Proposed Revisions to a Standard Plans Index

Index Number: 700-030

Index Title: Wind and Hanger Beams for Overhead Signs

TYPICAL SIGN FOR OVERHEAD TRUSS

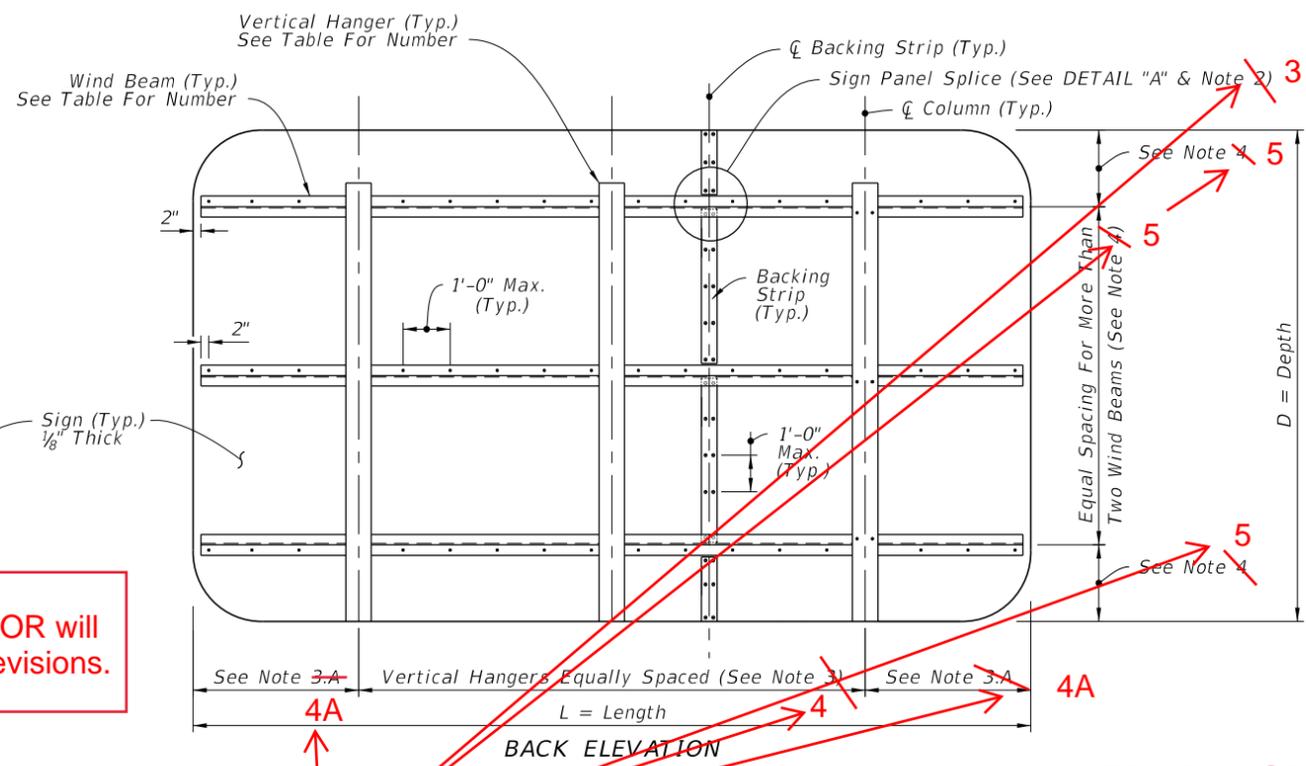
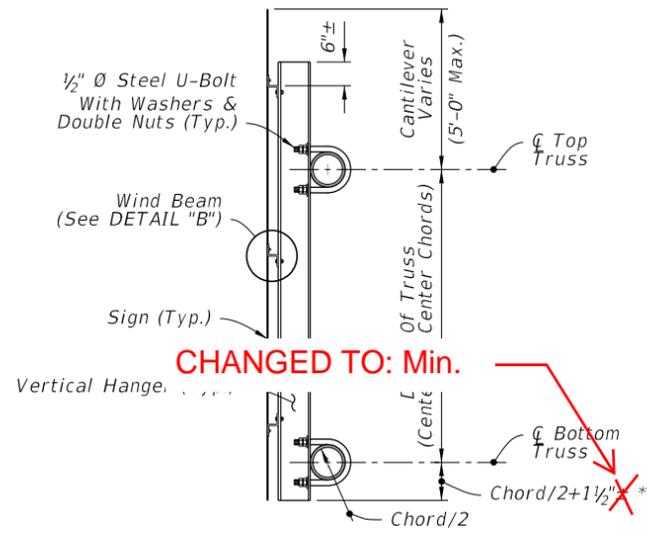
UPDATED: References (See General Note...)

DETAIL "A"

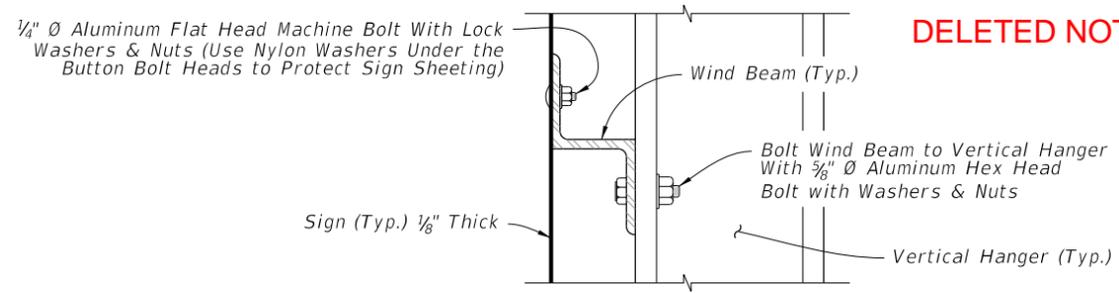
Added New General Note 1 - "Meet requirements of Specification 700."; Deleted Notes 6 and 7; Renumbered Notes; Updated General Note references in the TYPICAL SIGN FOR OVERHEAD TRUSS details; Changed the tolerance symbol "+/-" for the edge distance of the bottom U-bolt to a "Min."

A tolerance of +/- suggests that the 1 1/2" dimension could be less and by some undefined amount. While any additional edge distance would not be structurally significant we wanted to put a lower limit on the edge distance.

DELETED NOTES

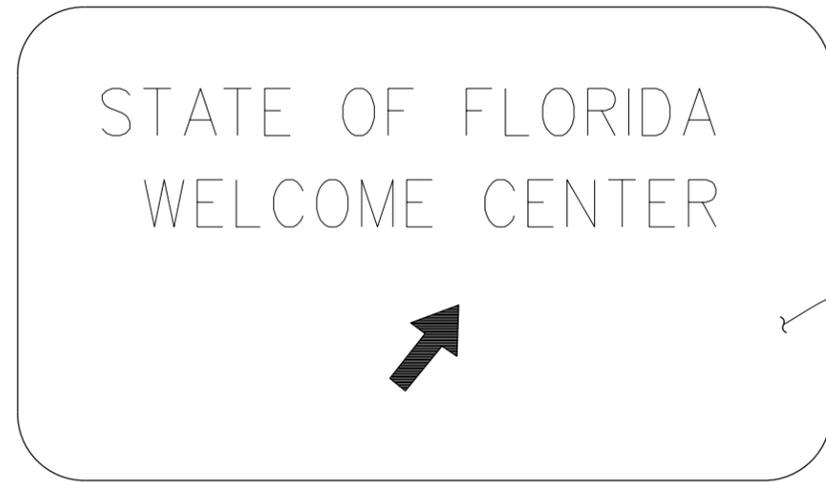
GENERAL COMMENT: Some material information was deleted. Information is either already covered in Standard Specifications OR will be added to Section 700, 962 or 965 in conjunction with these revisions.

ADDED NEW NOTE 1: Meet the requirements of Specification 700.
